# Modification Recommended Service Note

## 6671A DC power supply, 0-8 V, 0-220 A, 1760 W. GPIB

Serial Numbers: "MY53000140 to MY53000698 and SG53000101 to SG53000108"

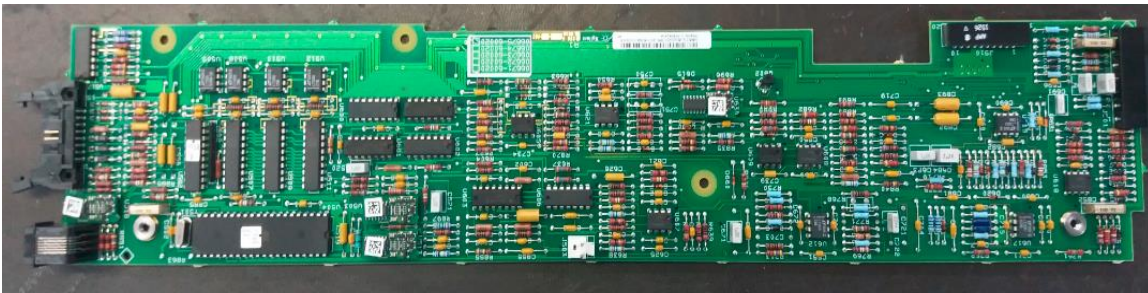
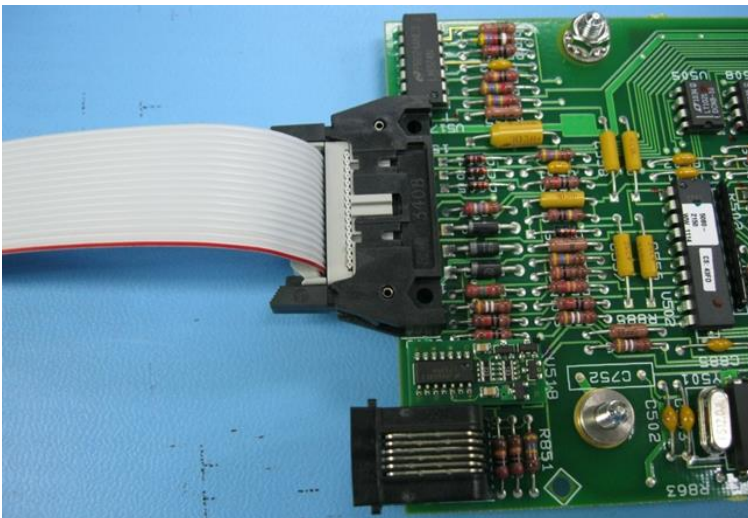
6. Replace with a new PCA board (06671-61020).
